DEFENSE NUCLEAR FACILITIES SAFETY BOARD

**SAVANNAH RIVER SITE
IN-TANK PRECIPITATION FACILITY
BENZENE GENERATION:
SAFETY IMPLICATIONS**

Technical Report

February 3, 1997

Figure 2. Tank 48H Temperature History

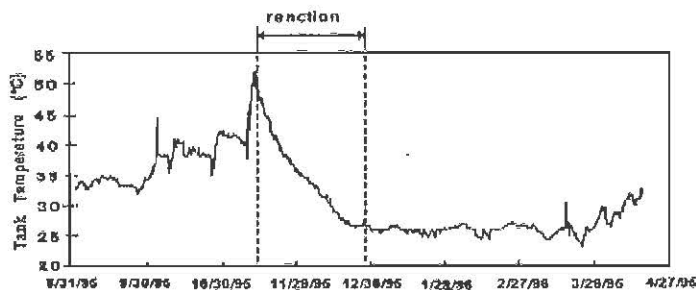
There is substantial evidence that elevated temperature and/or elevated oxygen may have helped to initiate the process excursion. The maximum bulk temperature was 52°C , and the maximum oxygen concentration was 20 percent.

Figure 4. Calculated Time to CLFL

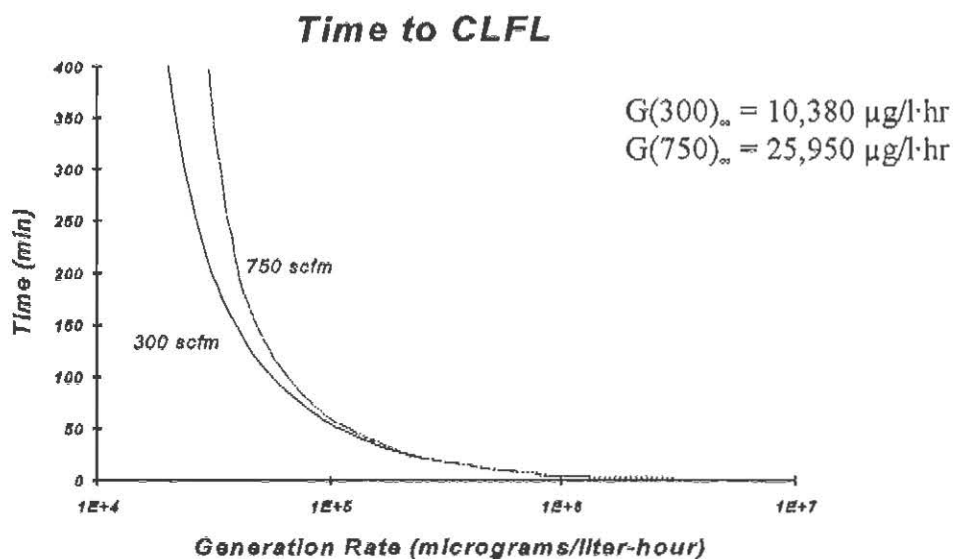
concentration. Figure 4 provides a graph of the time required to reach the CLFL for various benzene generation rates (with no retention), given a slurry volume of 300,000 gallons and purge flow rates of 300 scfm (design minimum) and 750 scfm (typical system flow rate). From these calculations, it is clear that the retention of the benzene in the slurry was fortuitous.

Board staff believe that the benzene retention property of the solids was the only barrier to a flammable concentration of benzene during the process excursion. A more limiting case might involve another method for the release of benzene other than pump operation. For example, the benzene could be released with the use of a surfactant if the benzene were held by surface tension with solids in the liquids.
